Documentation of RM 2243 - Corridor Study Open House

Ranch-to-Market (RM)-2243 Corridor Study

CSJ: 2103-01-032

RM 2243 – Corridor Study – Thursday, November 29, 2018 – Comment/Response Matrix

From: [Amy Lynn Payne](#)
To: [Sonya Hernandez](#)
Cc: [Blake Magee](#)
Subject: RM 2243 Corridor Study Comments
Date: Wednesday, December 12, 2018 3:43:23 PM
Attachments: [20181212_175135.pdf](#)

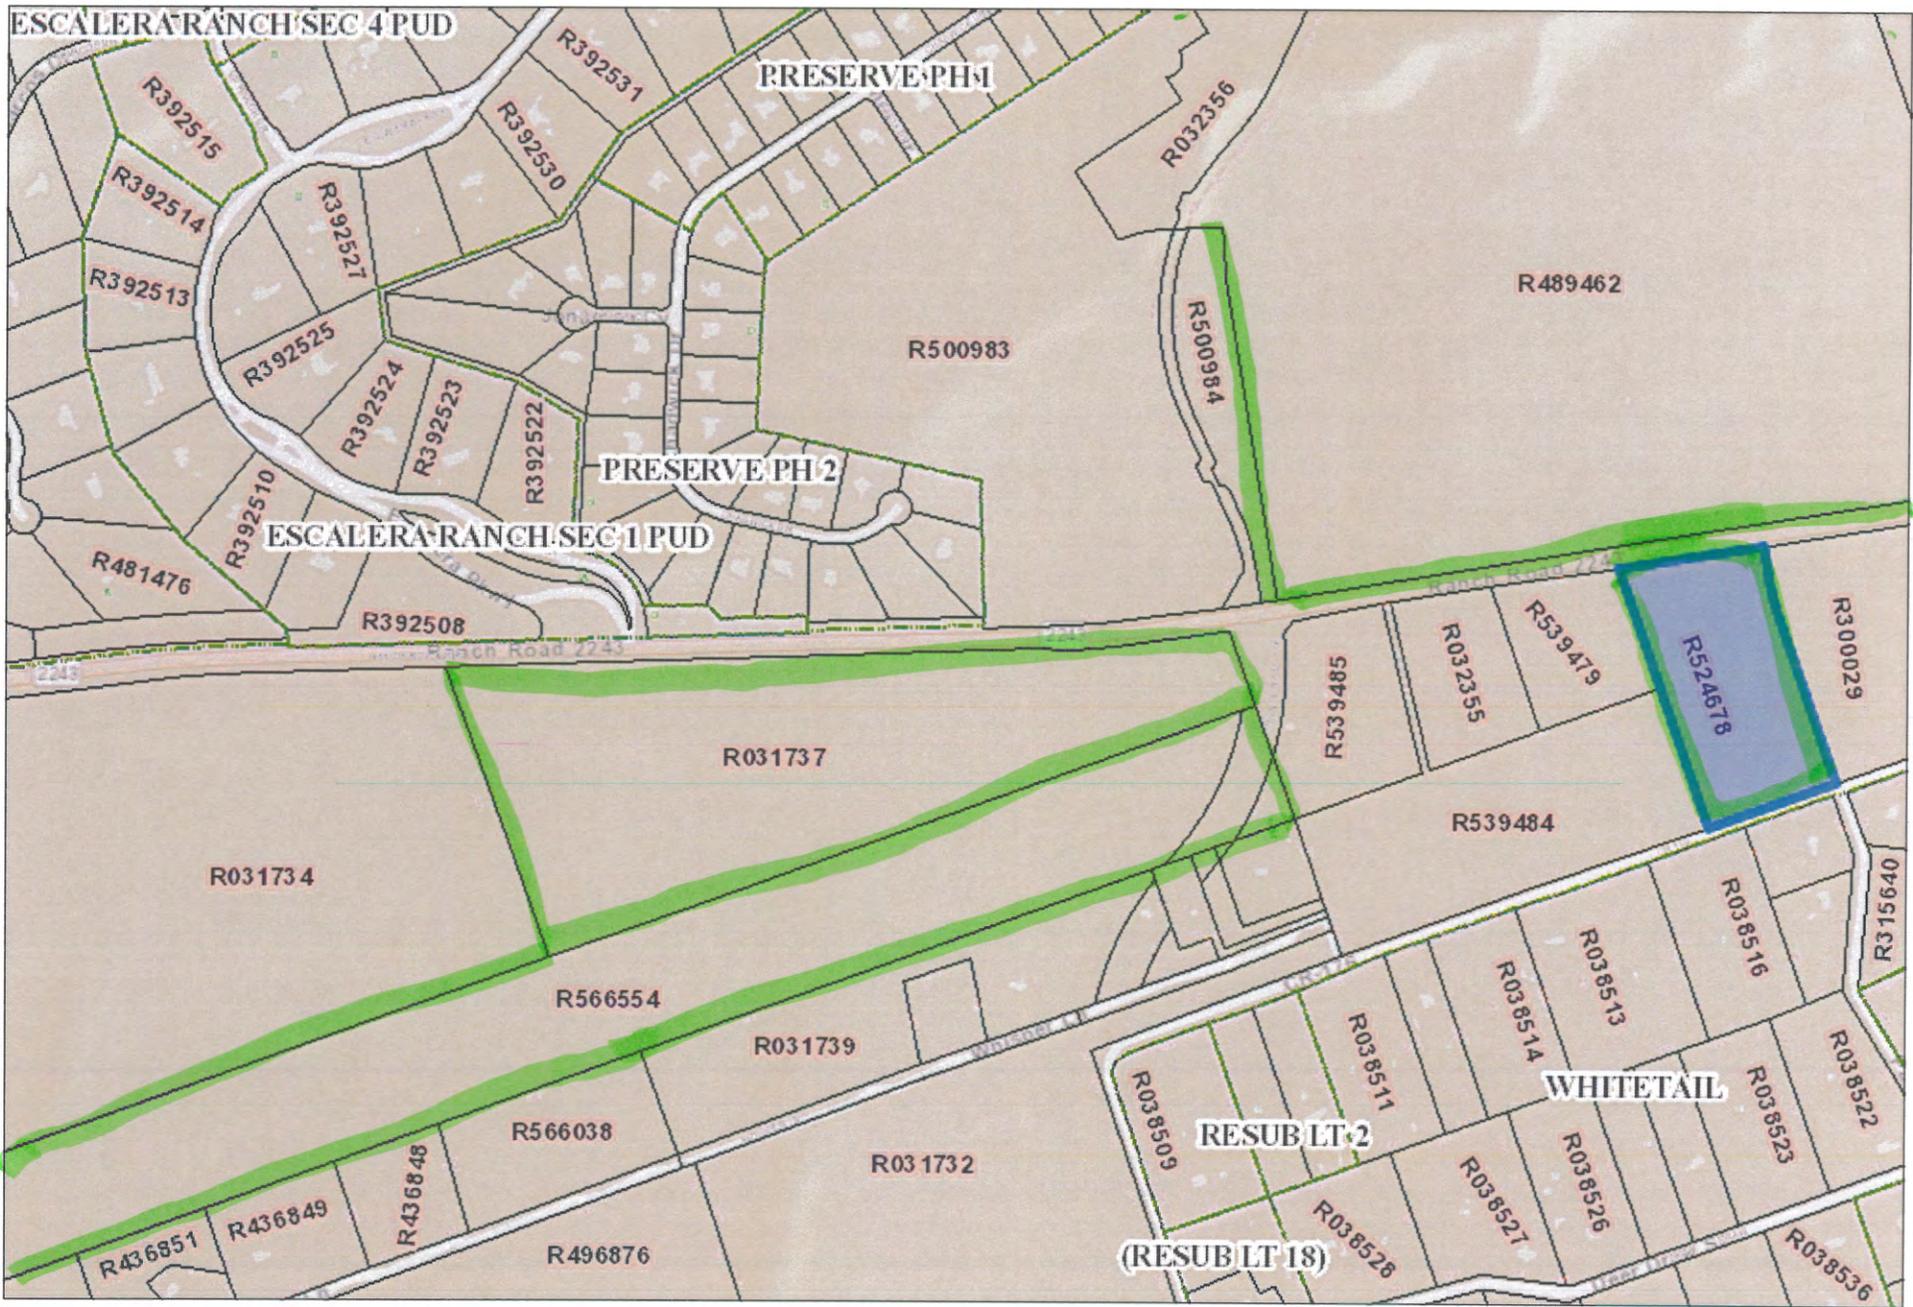
Good Afternoon Sonya, we were unable to attend the public meeting to discuss the RM 2243 Corridor Study but we would like to meet with you to discuss TxDOT's upcoming plans for this project. We own land on both sides of RM 2243 as shown on the attached maps. Over the last year we have been in discussions with Commissioner Valerie Covey on the ROW needed for the 2243 widening and how our properties would be affected. Please let me know when it would be possible to meet and discuss this further. Please feel free to give me a call.
